Compliance Assessment Report CAR_NRW0052101

Permit being assessed: AN0235601

For: Hafod Quarry, **held by:** TARMAC TRADING LIMITED

Parts of permit assessed: Site drainage infrastructure

Figure 10 – Surface water discharge system on entrance/exit road (2022)

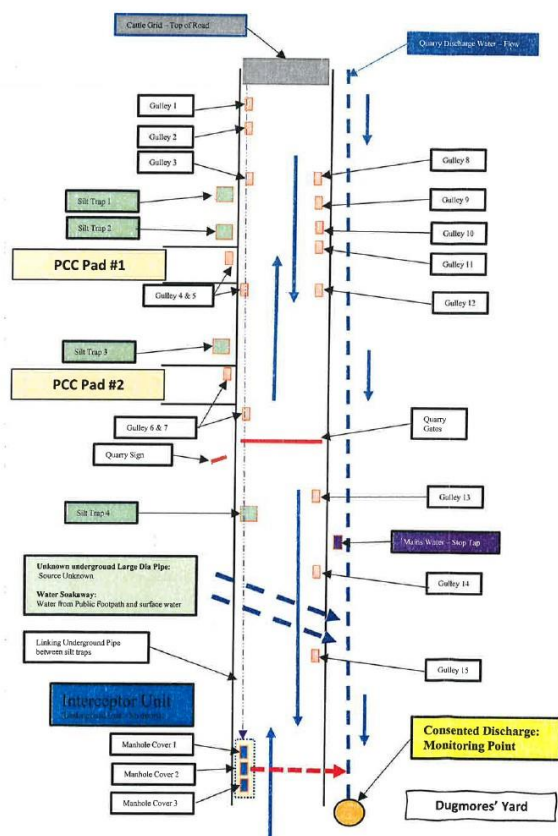
Drainage plans for the enclosed road drainage system were available and can be seen in Figure 10. It is noted that the plan is dated 2022 but LJ was not aware of any changes made since this plan was created.

7. Undertake a full survey and assessment of the road drainage system to form an updated plan and confirm how it works. Any issues/faults shall be identified and communicated with NRW to agree an acceptable deadline to complete remedial works.

Figure 18 – The permitted sample point on a subsequent check during the visit.

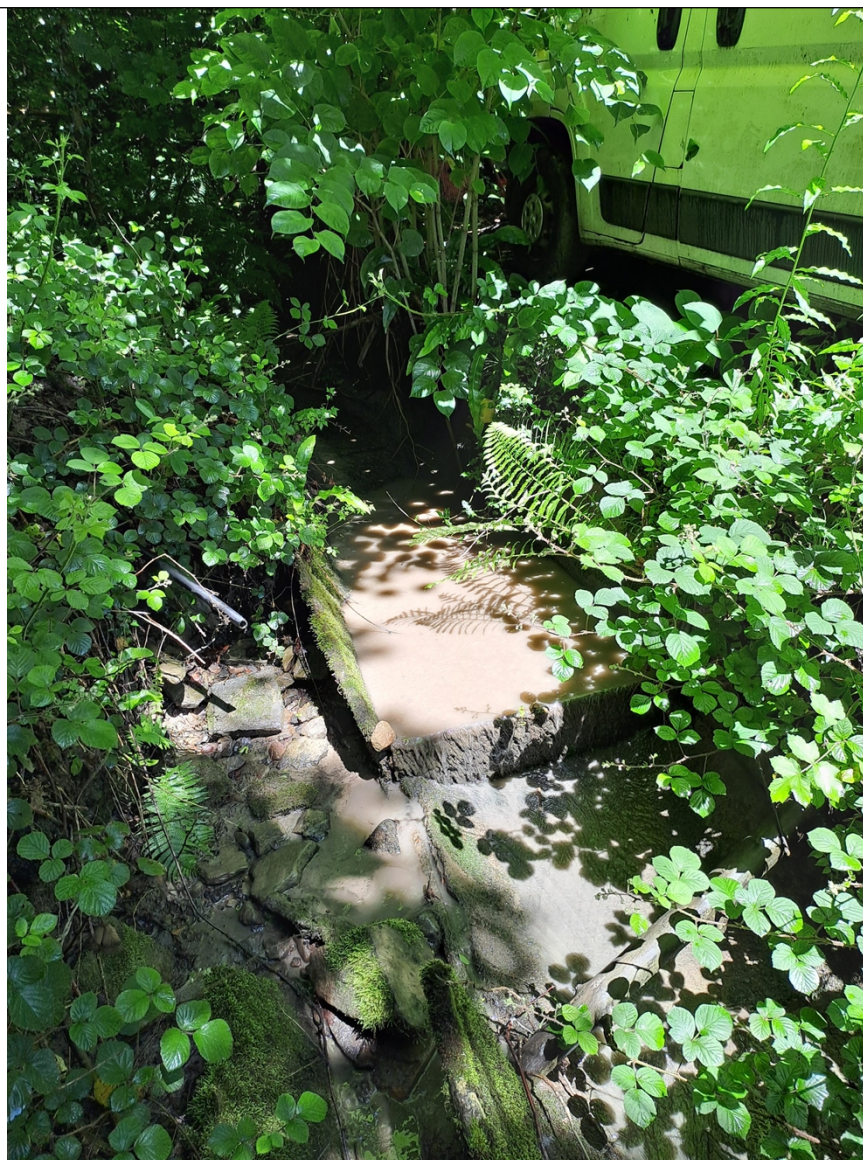
Due to the apparent significant volume of silty water discharging from Manhole 2, the discharge point was checked again and found to be considerably siltier than when it was observed earlier in the visit. As such it suggests that this is the primary reason that continued breaches of consented limits are being experienced. This can be seen in Figure 18. While visually it was apparent that this was breaching the site discharge limits, I did not sample the discharge at the time of the visit and I have not scored it as a breach on this occasion. I have noted it as an ongoing non-compliance that we are working towards resolving. This is reflected below.

A visual assessment of the effluent clearly shows elevated suspended solids. No samples were taken at this time but regular exceedances have been recorded by NRW over the past several months. As such this has been recoded as an ongoing non-compliance and not a new/separate breach. See actions list below for corrective actions to resolve this issue.
